Transmission: 4L80E
Subject: Updates
Application: Chevrolet
Issue Date: 1995

4L80E

Updates

Technical Bulletin #266

Figure 1

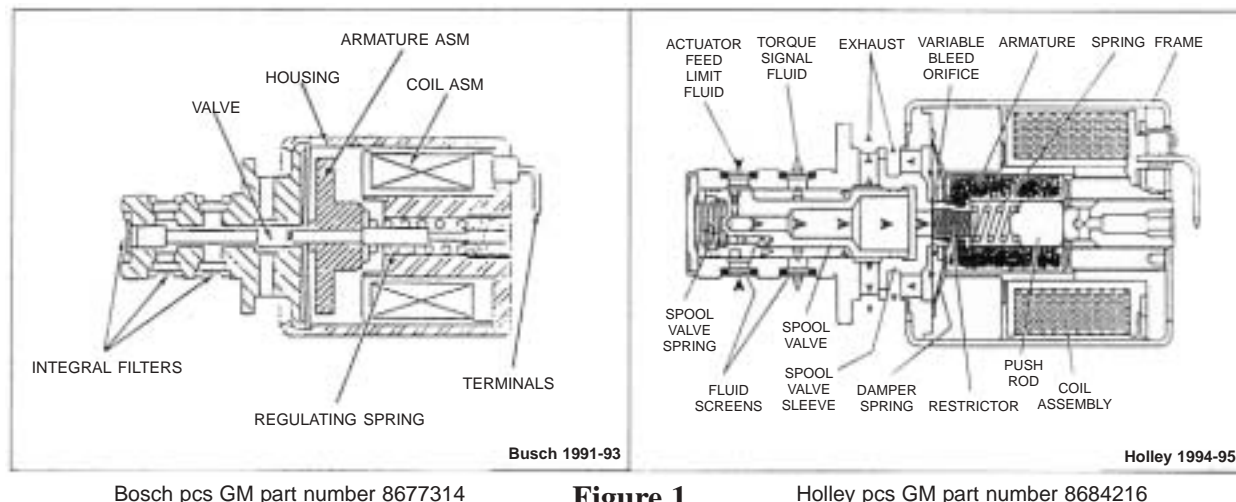
Beginning with the start of production for the 1994 model year all 4L80E models were equipped with a new designed pressure control solenoid (force motor). 1991-93 model units were equipped with a unit built by Bosch, which can be identified by its silver colored exterior. The new pressure control solenoid is manufactured by Holley and can be identified by its black

colored exterior. Internally, the solenoids vary greatly. The size of the spool valve has been increased and a spring was added to eliminate the need for the 10-second cleaning pulse. (Figure 1)

To accommodate this change, the oil channeling for the solenoid has been changed. This change removes the balance oil from the end of the solenoid, which means the Bosch unit must not be used to replace a Holley solenoid or high line pressure will result. In addition, the resistance of the new solenoid is slightly higher at 3-8W. With this slight increase in resistance, you will notice the duty cycle reading on your scanner or meter is also slightly higher while the amperage/pressure values remain the same as the Bosch Units. The duty cycle values for the Holley will normally read about 50 to 70% at idle and decrease as load is increased.

Figure 2

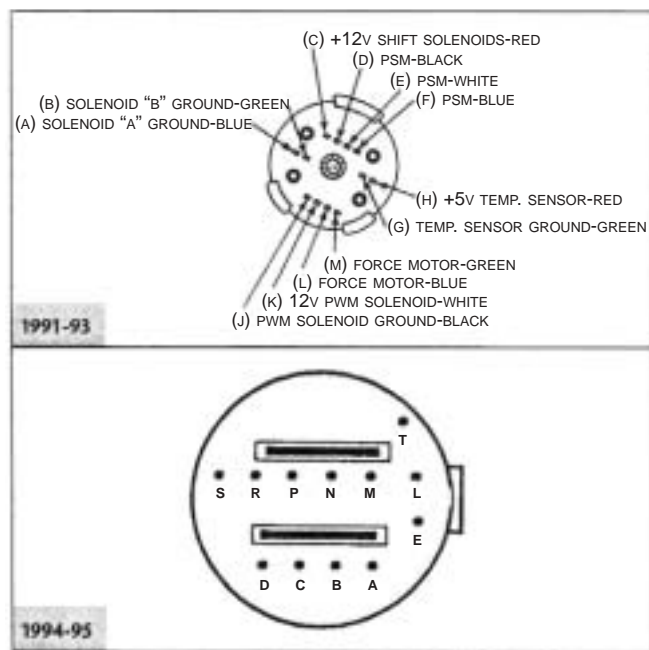
To reduce the possibility of leakage and multiple code storage a new connector was added to all 4L80E models. (Figure 2).

Figure 3

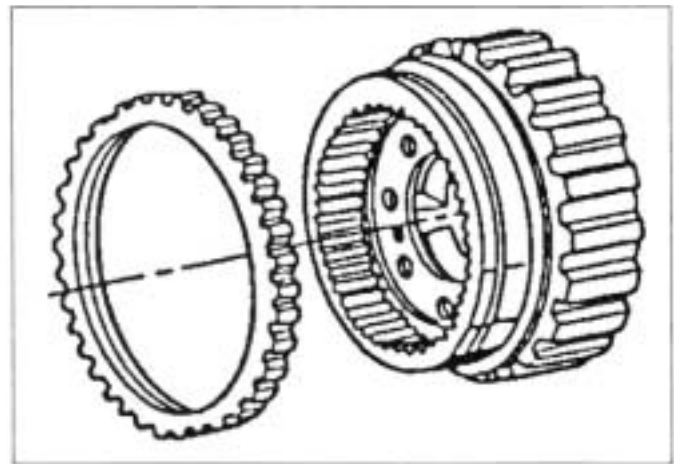
All 4WD units now use only output speed sensor (located at the transfer case) rather than sensors at the transfer case and the transmission output shaft. Since the output toothed wheel was also dropped (Figure 3), care must be taken not to interchange output planetary carrier assemblies between output VSS and non output VSS equipped units. Attention must also be given when replacing a unit with a rebuilt transmission to assure the transmission is properly equipped with or without a toothed sensor wheel.

If the wrong transmission part number or a carrier unit without a toothed wheel is installed in a 1991-93 vehicle, late/no upshifts may result.

NOTE: Late upshifts may result due to the sensor picking up a 21 pulse per rotation signal from the machined slots cut in the output planetary assembly, rather than the normal 40 pulse per rotation signal the PCM/TCM experts to see.

Figure 4

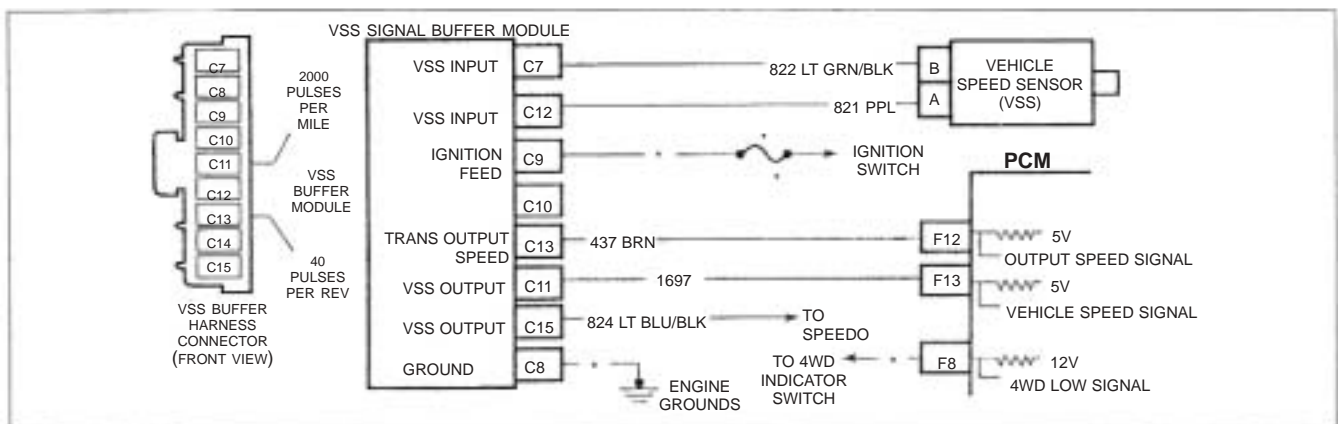
Both 1994-95 4WD and 2WD vehicles use the same wiring layouts for their output vehicle speed sensor circuits. (Figure 4)

Figure 5

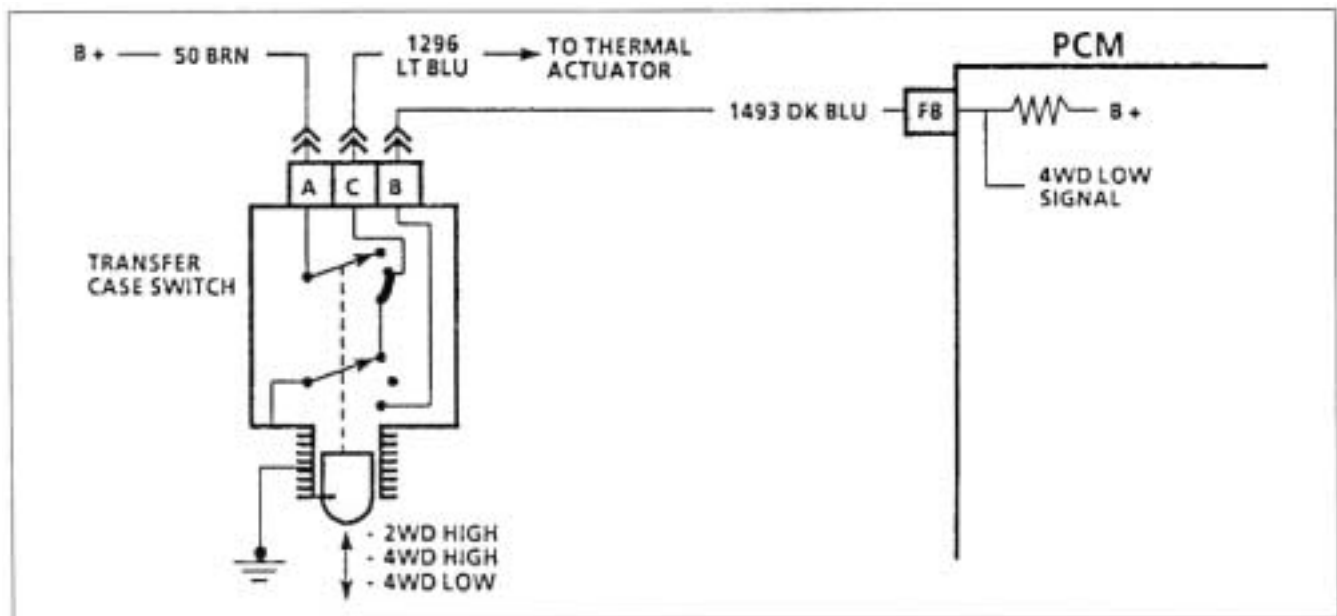
To accomplish this, the switch at the back of the transfer case, which was used to energize the front drive axle thermal actuator, has an additional set of contacts and an additional wire which signals the PCM when the 4WD LOW range is selected. (Figure 5)

During ranges other than LOW, the switch remains open and the PCM feed circuit 1493 remains at battery voltage.

As the Low range is selected, the transfer case switch grounds circuit 1493. This pulls the signal voltage at the PCM low and signals the PCM to change the vehicle up/down shift points to accommodate the change to 4WD LOW range. 4WD LOW switch position is indicated as a scan tool parameter on 94-95 vehicles.
